Loudoun County, Virginia

ADDENDUM NO. 4

RFQ 101780

The following changes and/or additions shall be made to the original Invitation for Bid, RFQ 101780: Renovation of the Sterling Community Center. Please acknowledge receipt of this addendum by signing and returning with your proposal.

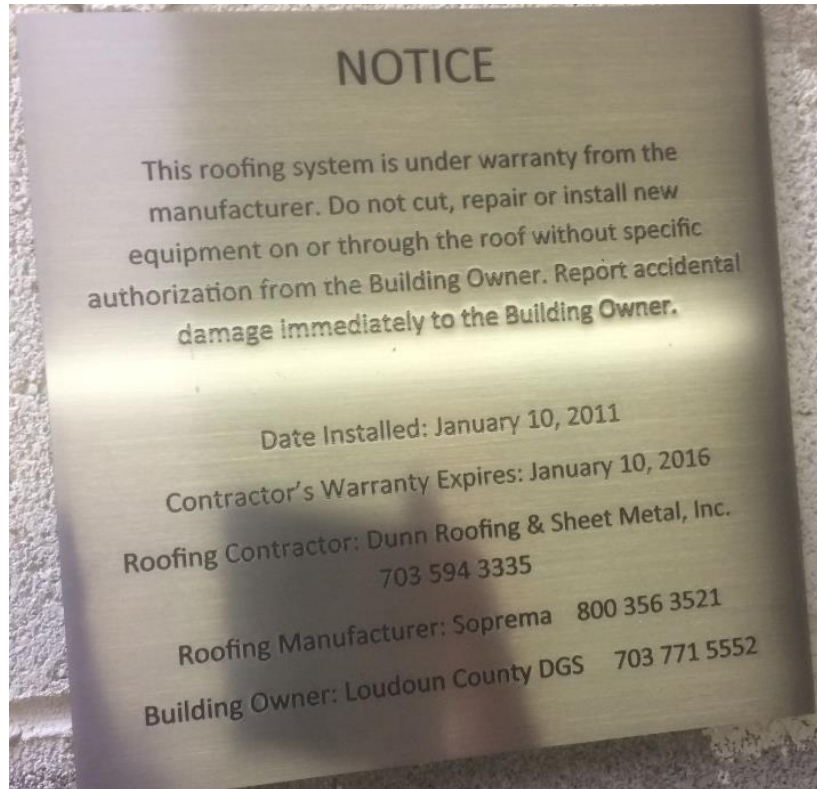
Q5: What thickness should we use to price "match Existing Thickness" on page S101?

Q7: Please provide information on the existing roof. Manufacturer, section, date of installation etc. if available.

A5: Per existing drawings, the top of existing spread footing along Grid 2 is 2'-8" +/- from top of existing slab-on-grade. GC to field verify. See existing drawings in Addendum.

A7: There is very limited information on the existing roof available. A plaque near the Northern Roof Hatch reads as follows.
